# UNITED STATES PATENT AND TRADEMARK OFFICE

APPLICATION NO.	FILING DATE	FIRST NAMED INVENTOR	ATTORNEY DOCKET NO.	CONFIRMATION NO.
10/764,571	01/27/2004	Alain Gauthier	713-1029	9023

## Office Action Summary

SCREW ANCHOR FOR FRIABLE MATERIAL

Replacement Sheet

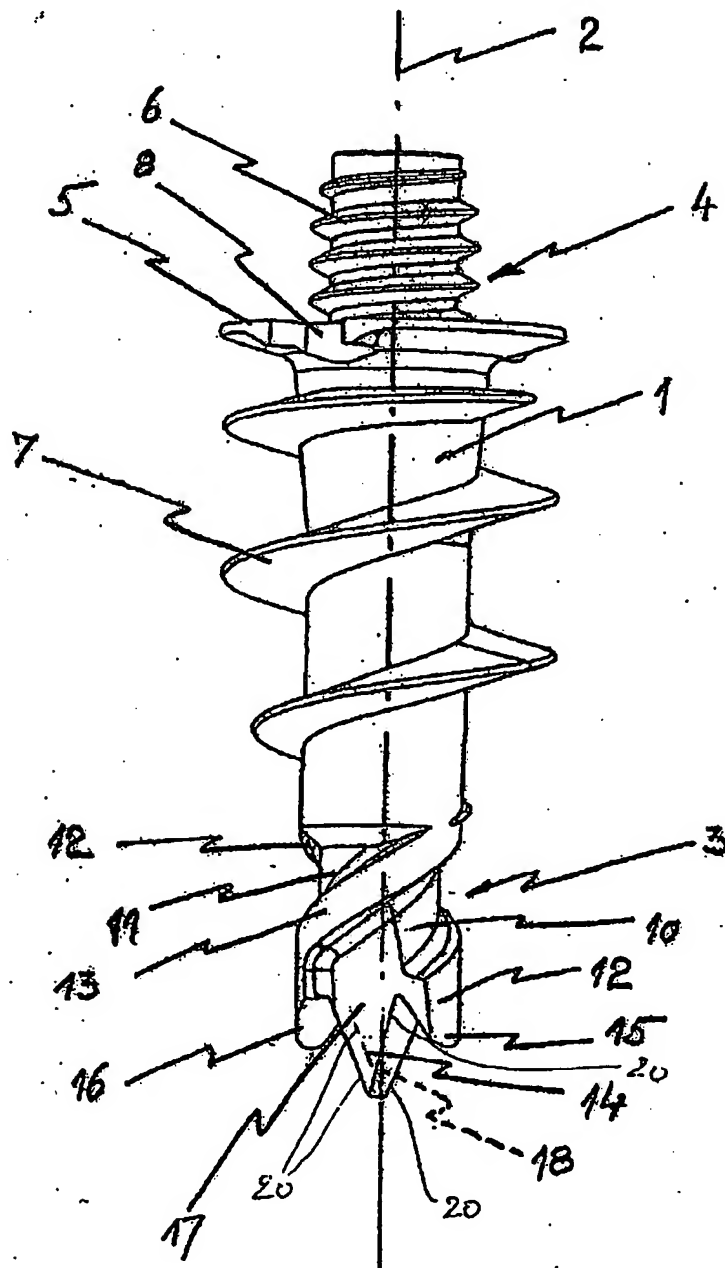
- [2] The drawing(s) were previously objected for informalities. In view of Applicant's replacement drawing(s) submitted on 7/25/2005, and amendment to the specification, all previous objection(s) to the drawings have been withdrawn. Accordingly, the changes have been entered.
